Shop Drawing Submittal Review

Project Name: Webster University-**ISB**

Copies	No.	Description
1 PDF	224216P02	(Submittal No.'s)
		(Cannon #22 4216.16-001) - (Paric #15051-) – (WES #607)
		➢ **Commercial Sinks**
		• Clinical Service Sink CSS-1
		• Scrub Sink SS-1
		• Sink SK-1
		• Garbage Disposer GD-1
		• Sink SK-2
		• Sink SK-3
		• Mop Sink MS-1
		• Kitchen Sinks KS-1, KS-2, KS-3

PROJECT NAME:	Webster University ISB
LOCATION:	St. Louis Missouri
CLIENT PROJ. NO.:	N/A
WES PROJ. NO.:	607
SPEC SECTION:	22 4216.16 Commercial Sinks
SUBMITTAL ITEM:	See Below -

1-**A/ 3-**A Copper Faucet Riser - One-Piece with Insert

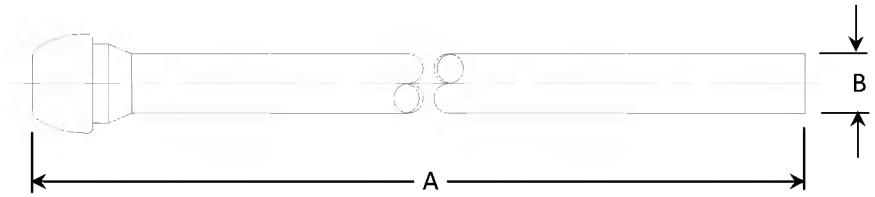
X					P-Trap Proflo Model PFPTB403	
X					Angle Stops BrassCraft Model SCR19XC	
X					Supply risers BrassCraft Model 1-12A C	
	X				Escutcheons Proflo Model PFE7	Escutcheons are specified to be cast brass. Refer to specification section 220518.
Sink SK-1						
X					Fixture Elkay Model GECR2521	
X					Faucet Chicago Faucet Model 200-AABCP	
X					Outlet Waste Disposer Kit Proflo Model PFEWB200	Provide under counter waste and supply protective piping covers as required. Verify requirements with the architectural drawings.
X					P-Trap Proflo Model PFPTB403	
X					Angle Stops BrassCraft Model SCR19XC	
X					Supply Risers BrassCraft Model 1-12AC	
	X				Escutcheons Proflo Model PFE7	Escutcheons are specified to be cast brass. Refer to specification section 220518.
Garbage Disposer GD-1						
X					Fixture Emmerson In-Sink-Erator Model Evolution Compact	
Sink SK-2						
X					Fixture Elkay Model LRAD1517	
X					Faucet Chicago Faucet Model 895-317GN2AE29ABCP

X					Supply Risers BrassCraft Model 1-12AC	
	X				Escutcheons Proflo Model PFE7	Escutcheons are specified to be cast brass. Refer to specification section 220518.
Sink SK-3						
					Fixture	Sink is integral with the countertop. Coordinate with architectural drawings.
X					Faucet Chicago Faucet Model 786-GN2BVBE3-2ABCP	
X					Drain Assembly Elkay Model LK35	
X					P-Trap Proflo Model PFPTB403	Provide under counter waste and supply protective piping covers as required. Verify requirements with the architectural drawings.
X					Angle Stops BrassCraft Model SCR19XC	
X					Supply Risers BrassCraft Model 1-12AC	
	X				Escutcheons Proflo Model PFE7	Escutcheons are specified to be cast brass. Refer to specification section 220518.
Mop Sink MS-1						
X					Fixture Fiat Model TSB-3000	
X					Faucet Symmons Model S-2490	
X					Hose Bracket Proflo Model PF296	
X					Hose Proflo Model PFSSHE	
X					Mop Bracket Proflo Model PF245
